Our Case Number: ABP-317682-23

Re: Kimmage to City Centre Bus Corridor Scheme, Compulsory Purchase Order 2023

Re. Kimmage to City Centre Core Bus Corridor Scheme Observation & Objection

## Appendix 1

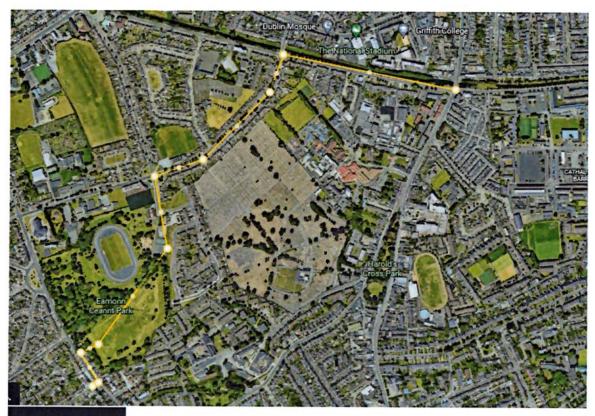
Alternative cycle way

Through park, greenway cycle

Clogher road has sufficient width to allow for segregated cycleway to meet up with Canal

Slightly longer but the additional safety benefit should encourage usage

Potential direct access could be established through the Council depot opposite Blarney Park, further reducing mixing with traffic.

Mostly along narrow road with designated but not protected cycleway.

## Mostly urban

Not enough width for designated protected cycleway
